PLANNING COMMISSION STAFF REPORT

Originator Cary Teague Community Development Director	Meeting Date July 24, 2013	Agenda # VI.A.
---	--------------------------------------	--------------------------

Rodney Helm on behalf of Tom and Gretchen Shanight is proposing to subdivide the property at 5612 Tracy Avenue into two lots. (See property location on pages A1–A3.) The existing home would be torn down, and two new homes built on the new lots. (See applicant narrative and plans on pages A4–A16.) To accommodate the request the following is required:

Re: Preliminary Plat for Shanight Addition
Dated June 25, 2013

A15

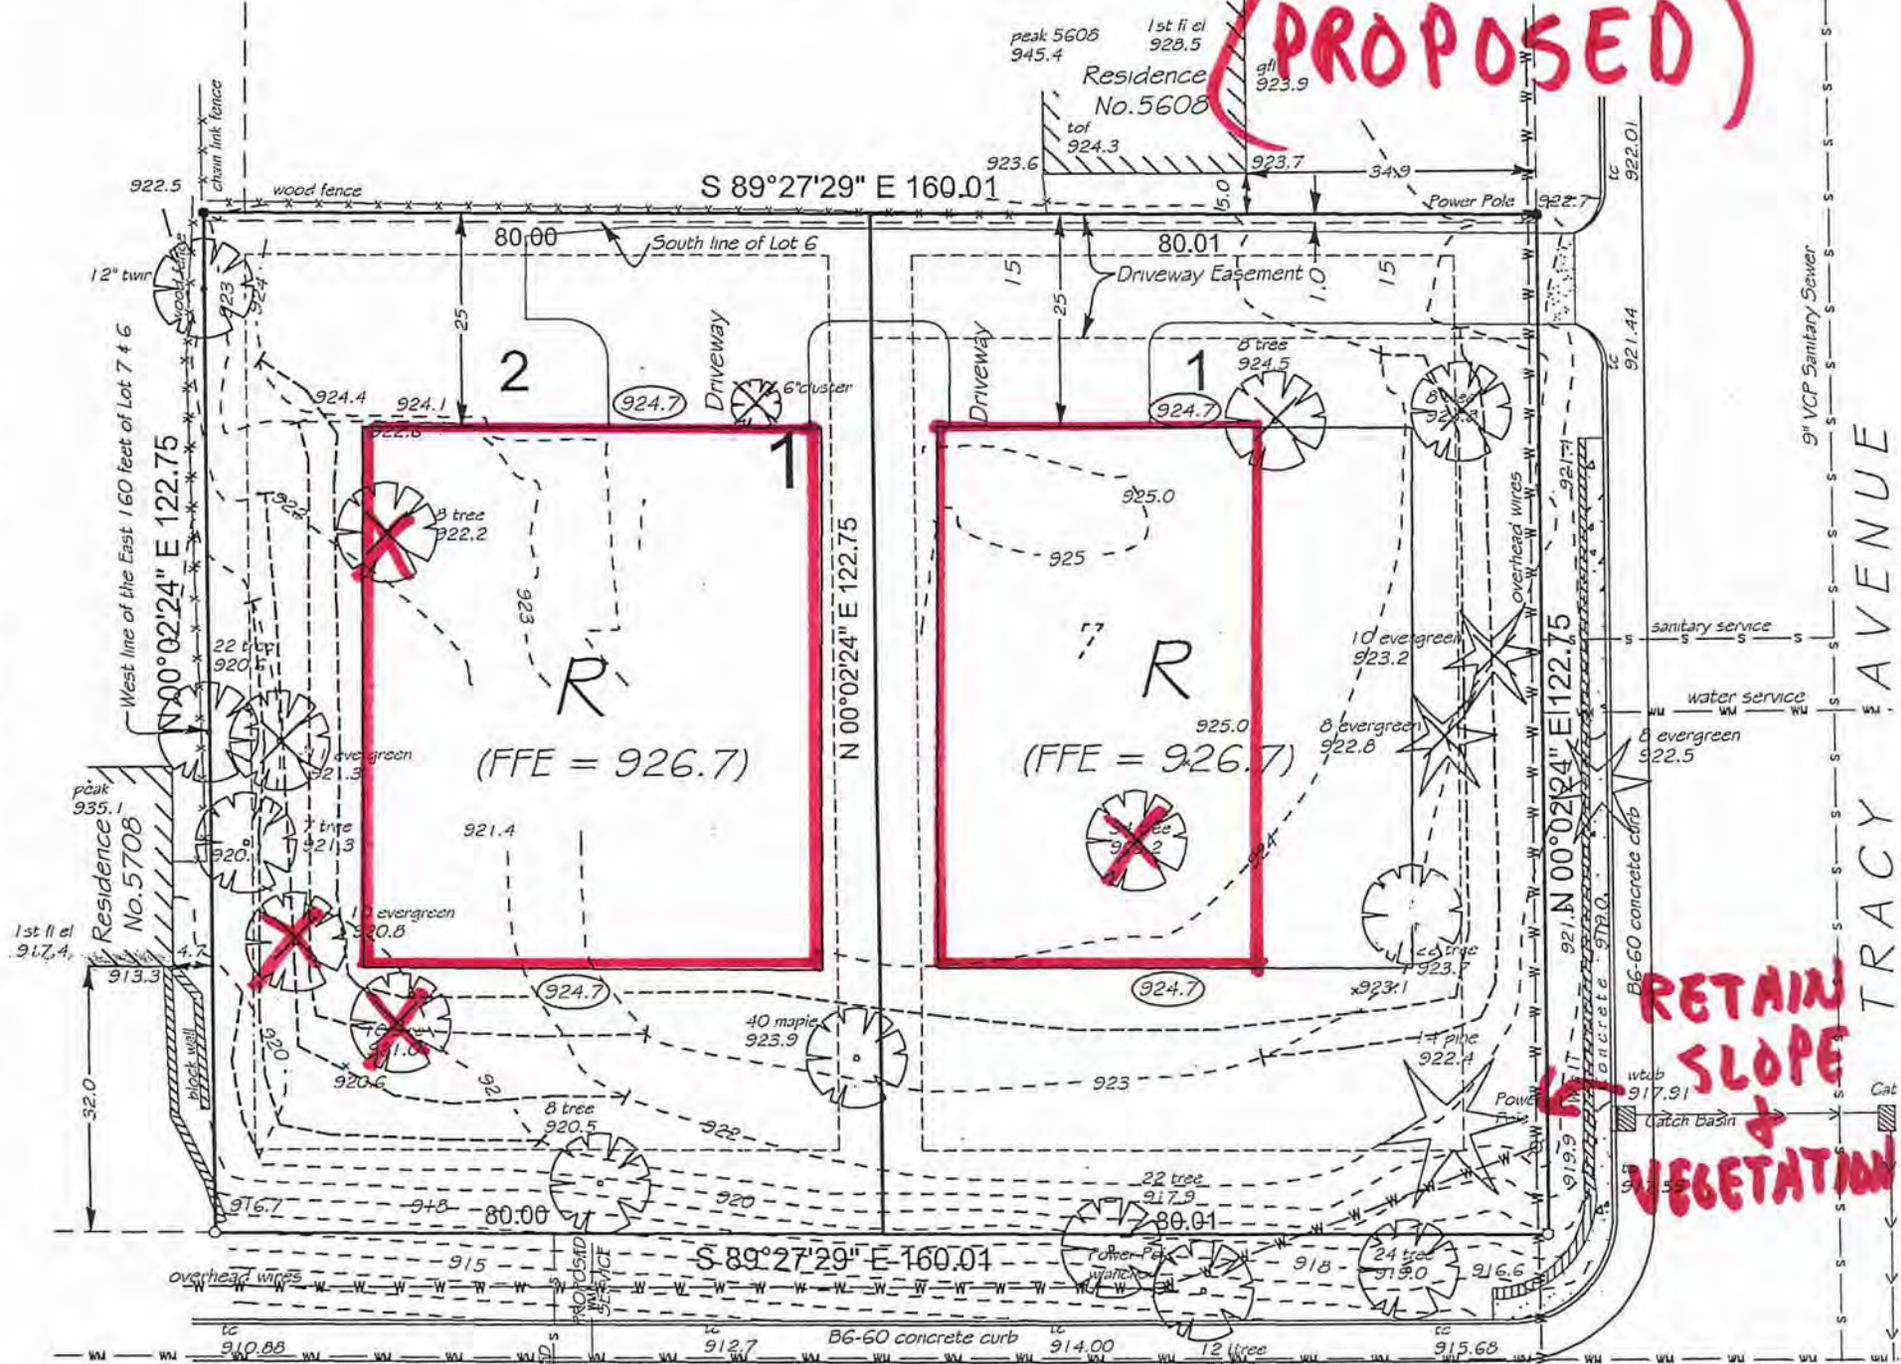
The grading plan shows the buildable area for Lot 1 with a 15 foot setback off of Tracy Avenue. (See page A15.) The required setback is 35 feet, to match the setback of the home to the north. If this subdivision is approved, it would not approve a building pad for a 15-foot setback. However, as indicated on page A15, there still would be adequate building area for a new home. There would be a building pad of 39 feet by 65 feet or 2,535 square feet.

No. The proposed improvements requested by the variance would not alter the essential character of the neighborhood. The neighborhood includes a vast majority of single-family homes on similar sized lots as proposed. The applicant proposes not to disturb the character along Hawkes Terrace, by utilizing the existing driveway off of Tracy Avenue to access both lots. (See page A15.)

- Change background on plan to show improved Tracy Ave; the current plan does not show the concrete curb and gutter bike lane.
- Provide a swale from the southwest corner of the building pad of Lot 2 to Hawkes Terrace.
- To minimize the disturbance of the vegetative buffer along Hawkes Terrace, I would recommend that the applicant look at utilizing the current driveway apron on Tracy Ave for both driveways. I typically recommend removing driveways from collector streets to minimize access to busier roadways. I also recommend that the driveways be designed to have turn-around spaces so the exiting vehicles can drive into traffic versus backing into traffic.
